Brisbane Central Business District Bicycle User Group

The CBD BUG has recently become aware of Council plans to perform works at the intersection of Kedron Brook Road and Days Road in Wilston, replacing the existing roundabout with a signalized intersection (Figure 1).

DAYS RD / KEDRON BROOK RD INTERSECTION UPGRADE GRANGE AND WILSTON

Figure 1

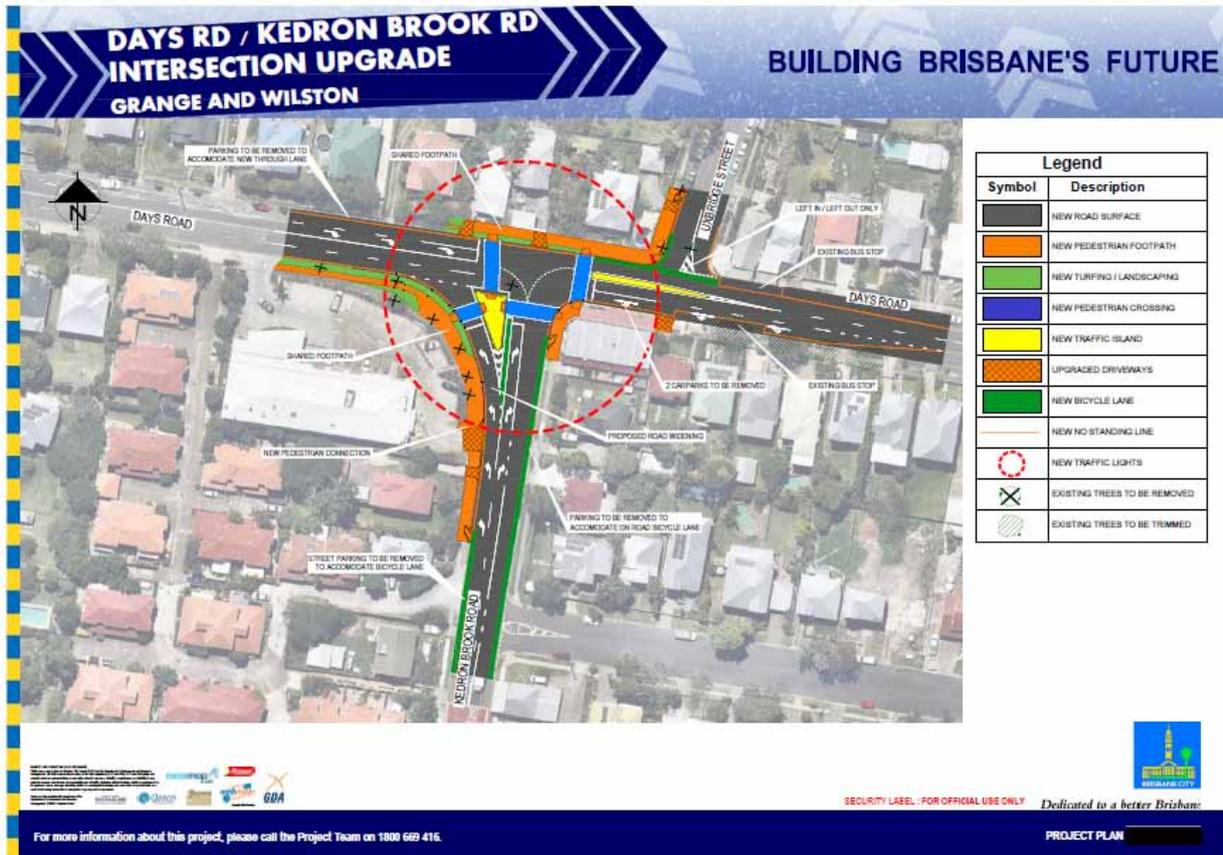
We are concerned that while council officers may claim the removal of the roundabout as an “upgrade”, amenity is being downgraded for people who ride bicycles. People riding bicycles will be required to chose between convenience or their personal safety with the current proposal.

At the northern end of Kedron Brook Road car parks will be removed to “accomodate” (sic) a unprotected bicycle lane. Just north of this point the bicycle lane disappears at the crucial point where a person riding a bike and wanting to turn right is supposed to perform a “weave right” maneuver if they intend to turn right at the lights in order to reach Uxbridge Street and the recently upgraded connection to Kedron Brook Bikeway.

Figure 2

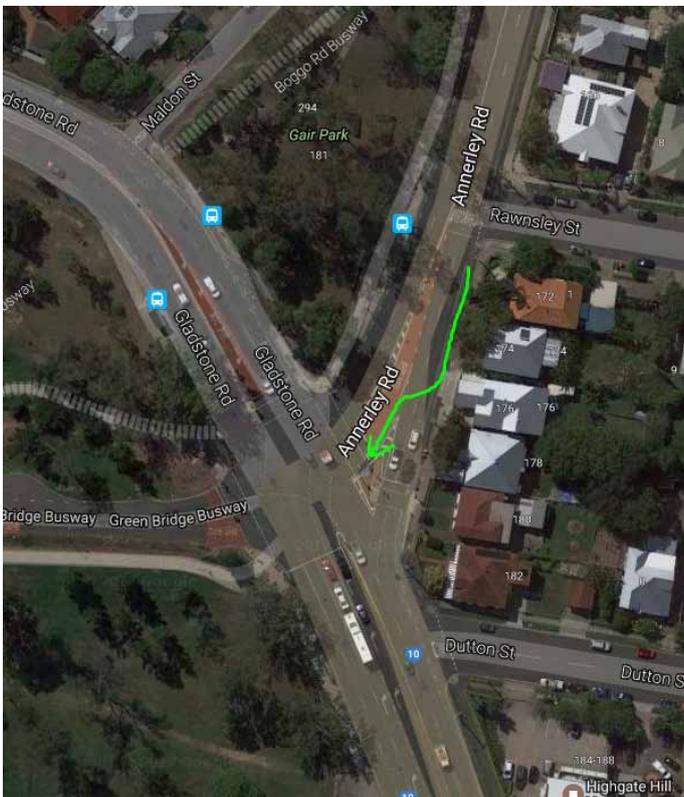
The design is similar to the current situation at the south end of Annerley Road (Figure 2, shown above). People travelling up the hill in the bike lane towards the intersection (with Gladstone Road) have the bike lane disappear at the crease then reappear again. This requires people to weave right, across two motor vehicle traffic lanes with a 60 km/h speed limit to reach the relative safety of the bike lane adjacent to the bus lane (Figure 3). This is an unpleasant and uncomfortable environment even for experienced bike riders.¹ The CBD BUG would like to point out that such a design is effectively a bike lane crossing a slip lane, a highly unattractive design. Also no design of bicycle infrastructure should require a person to be experienced to travel safely on a bicycle.

CBD BUG AMENDMENTS

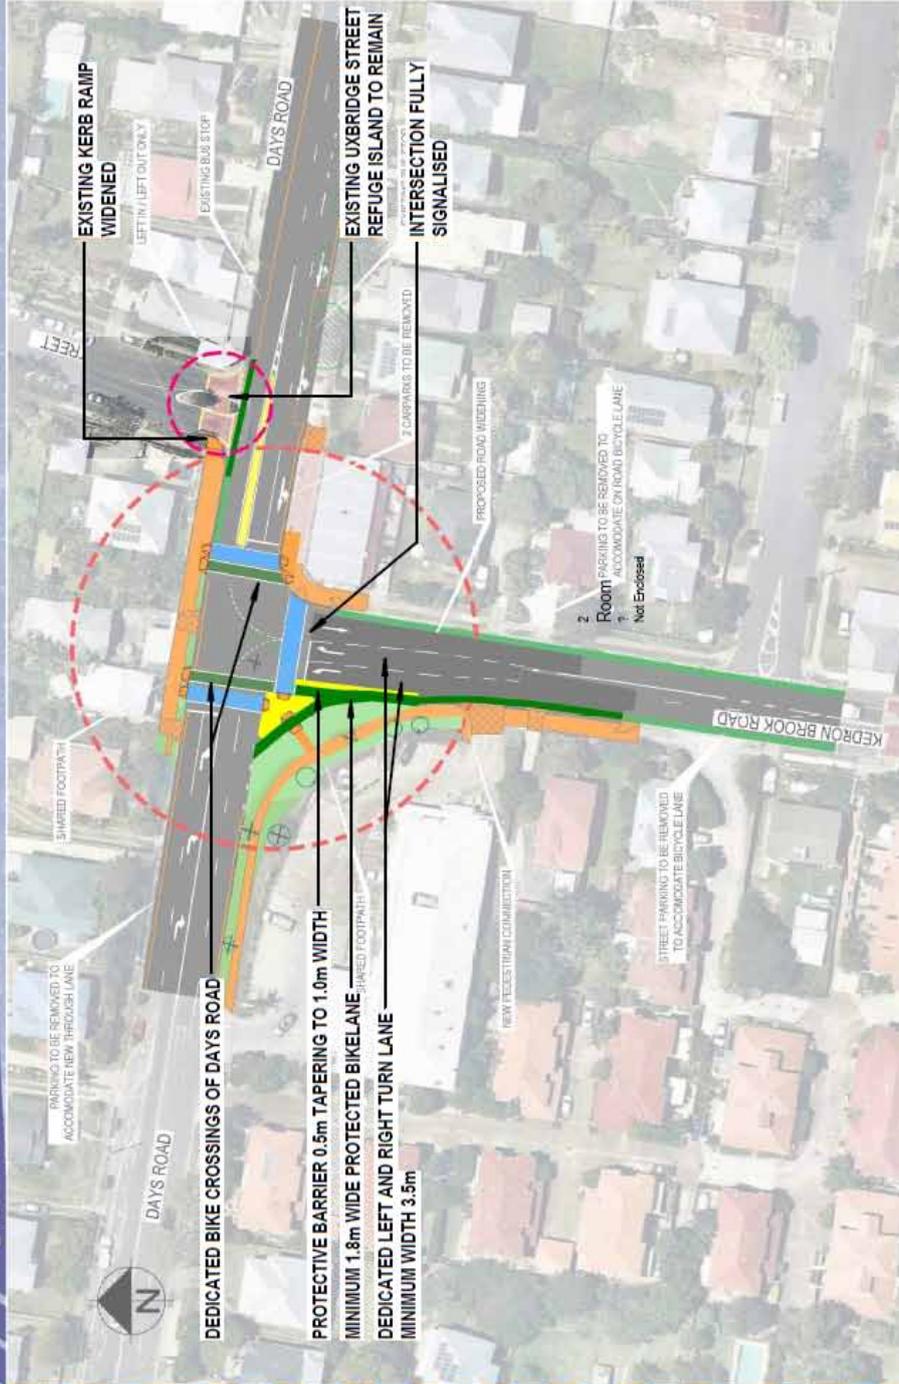
Using the Queensland Government's own guide the CBD BUG is providing an alternative proposal for the intersection upgrade (Figure 7).

- The proposed slip lane is removed. Slip lanes are highly dangerous for people riding a bicycle and completely unsuitable for people of all ages and abilities that may choose to ride a bicycle.

- Dedicated left and right turn lanes are provided for northbound motor traffic turning from Kedron Brook Road into Days Road.
- There is no change to Days Road as proposed in Council's design.

- A protected bike lane (of minimum width 1.8 m) is provided for north bound traveling bicycle traffic. The protective island widens from 0.5 m to 1 m in width.

- Bicycle traffic is provided with dedicated crossings of Days Road. This clearly identifies the presence and location of bicycle traffic.
- Uxbridge Street traffic Island is retained. Removing the traffic island on Uxbridge Street will reduce the safety of south bound bicycle traffic turning from Uxbridge Street onto the footpath of Days Road. The proposed painted island is not an effective form of protection and will do nothing to ensure the safety of pedestrians or people riding bicycles crossing Uxbridge St. The retention of the existing traffic will also reduce project costs.

- The kerb ramp from Days Road to Uxbridge street is widened.
- The intersection as drawn does allow for the northbound movement of a 19 m semi-trailer without placing northbound bicycle traffic at risk of serious injury.
